PLANNING COMMISSION – REGULAR MEETING

DRAFT Agenda

PLANNING COMMISSION MEMO

REQUEST: Special Use Permit & Site Plan

LANDSCAPE CALCULATIONS

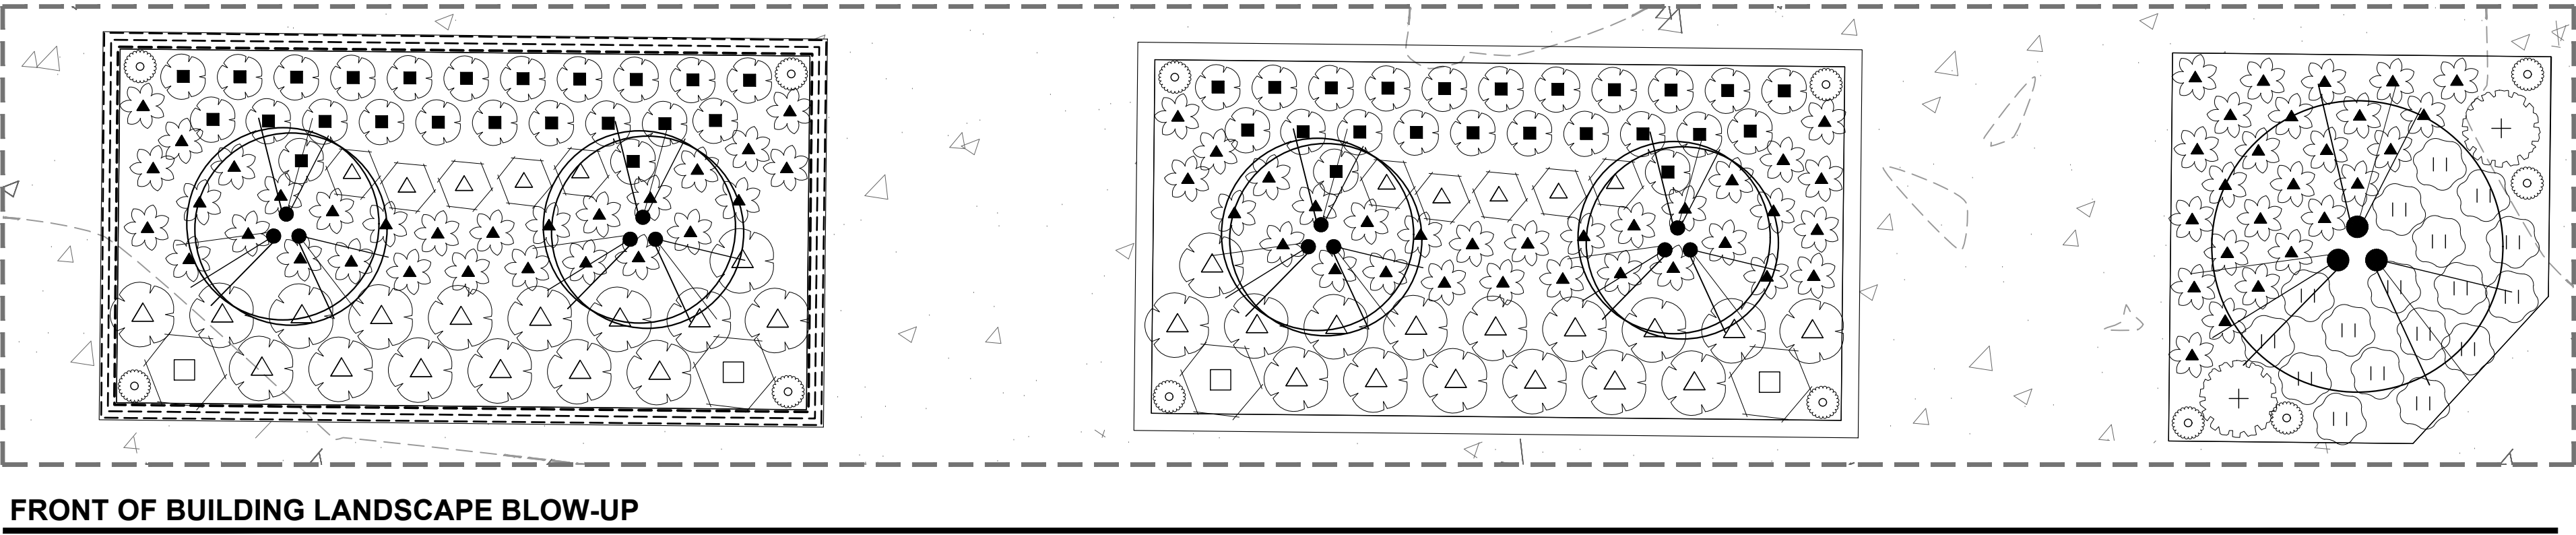
Staff notes that the Landscaping Calculations table on sheet L-110 includes references to an “East Beltline Overlay District”. Staff has determined these details were included in error and are not applicable or in reference to the GCTZO.
